AERONAUTICAL CHARTING MEETING
Instrument Procedures Group
Meeting 22-02 – October 24-25, 2022

RECOMMENDATION DOCUMENT

FAA Control # 22-02-372

Subject: Circling NA Areas and Implicit NA Runways

Figure 2. Circling authorized and not authorized areas showing procedure flow.

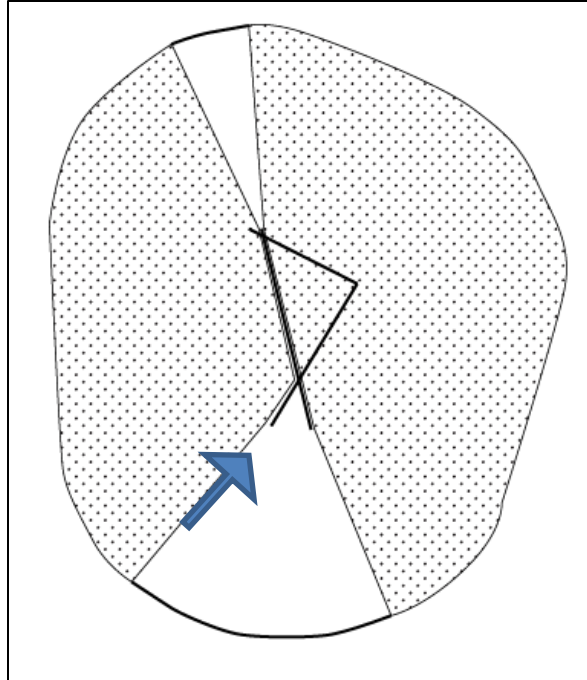
Considering this example and assuming night operations (which are the most restrictive), Figure 2 illustrates the areas both available (in white) and not available (in shading) for circling operations:

Figure 3. Annotated authorized and not authorized circling areas and runway callouts.

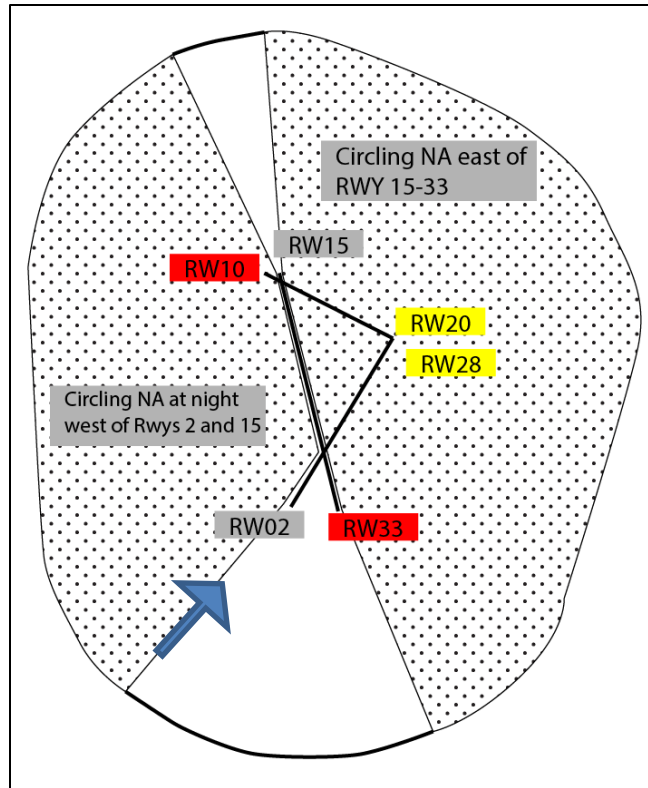
Figure 3 includes annotations of circling NA area notes along with runway callouts. Runways 20 and 28 are not reachable (yellow) because they are contained within the larger "Circling NA east of Rwy 15-33" area; as a consequence, the FAA does not specifically callout runways 10 and 28 as "NA." Runways 10 and 33 are unambiguously NA (red) based on the note "Circling Rwy 10, 33 NA at night". Runway 2 is unambiguously permitted. Runway 15 is ambiguous due to the splay area cutout and lack of note restricting circling to runway 15.

Most prudent pilots assume (rightfully) that Circling to Rwy 15 is NA at night on account of the two NA circling areas, but graphical application of TERPS criteria shows an open splay on runway 15 and no note specifically states that Circling is NA to runway 15. In our estimation, runway 15 ought to be added to the Circling NA at night note since runway 15 is unreachable other than by entering an NA area.

Garmin recommends a criteria change to cover cases like KYYK runway 15 and provide clarity via a chart note stating that a specific runway is NA.

Figure 4. Notional intent of NA circling areas.

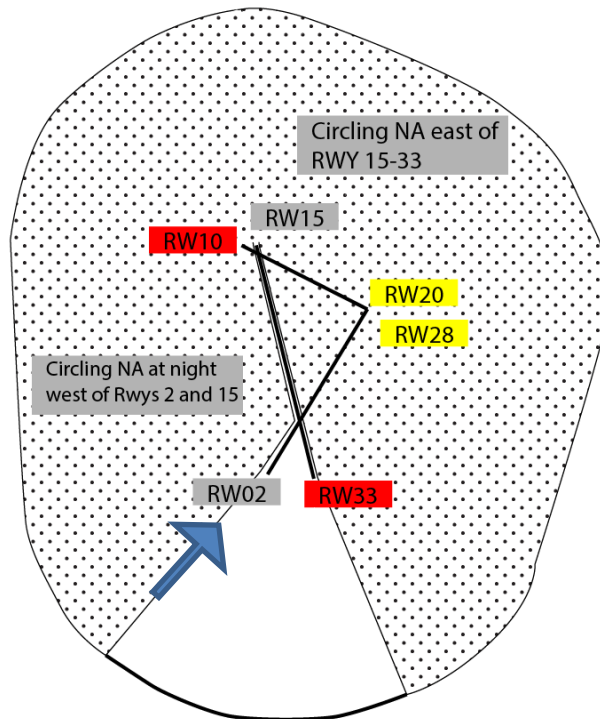
The other issue is the splay. Pilots don't have intimate knowledge of 8260 guidance on splay geometries. Accordingly, while the pie-shaped cutout north of the airport seems to be the consequence of notes "Circling NA east of Rwy 15-33" and "Circling NA at night west of Rwy 2 and 15," a clearer wording could be used to indicate what is likely intended and what is likely in the mind of the pilot as shown in Figure 4.

When more than one runway is used to define NA circling areas, improve splay design and/or wording used to describe the NA circling area.
